UNITED STATES  
NUCLEAR REGULATORY COMMISSION  
REGION V

License No. 04-17679-01E

Suncrux, Incorporated  
10440 North Tantau Avenue  
Cupertino, California 95014

MODULE TO CASE  
ASSEMBLY,  
TRITIUM

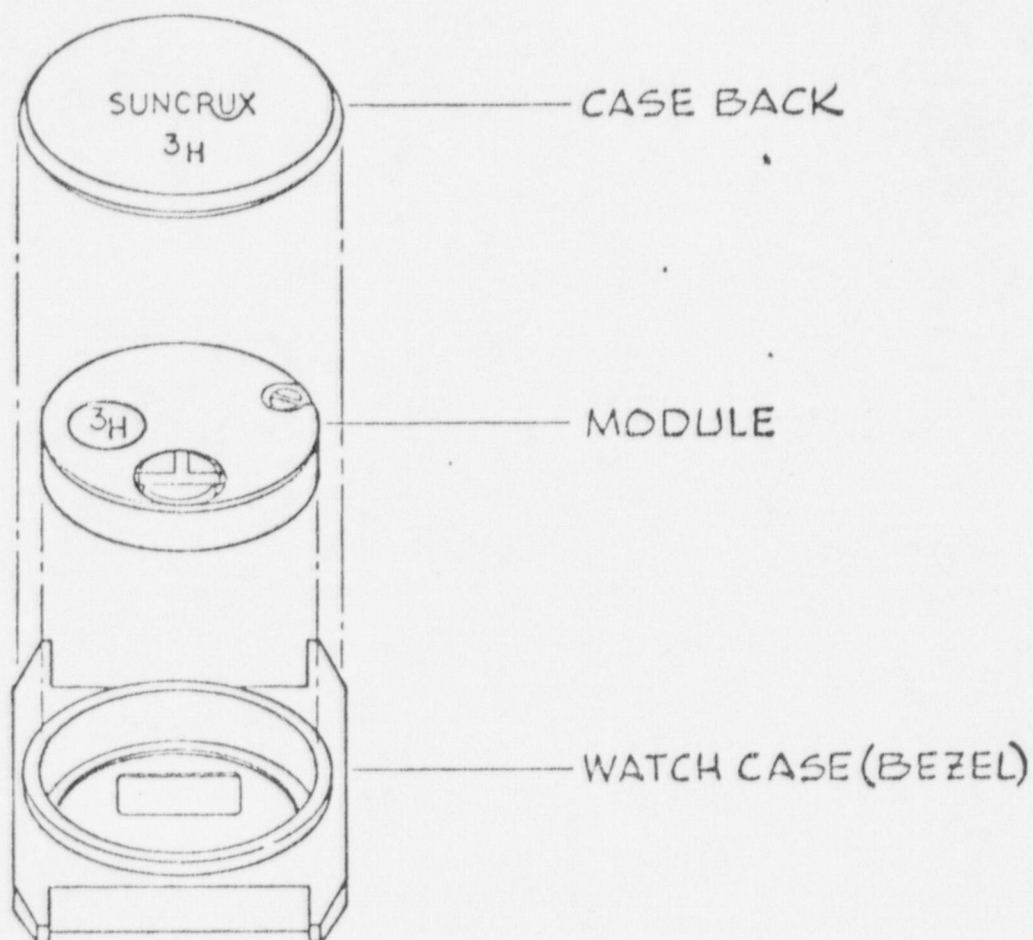
Your reply to Item C of the Notice of Violation did not state that watch markings to identify the presence of tritium and to indicate Suncrux as the manufacturer would be as shown in Drawing SK10777, included with the application dated October 6, 1977. (A copy of the drawing is enclosed for your convenience.) Please note that if the markings proposed in your letter differ from those in Drawing SK10777, you may need to amend your license to authorize the change.
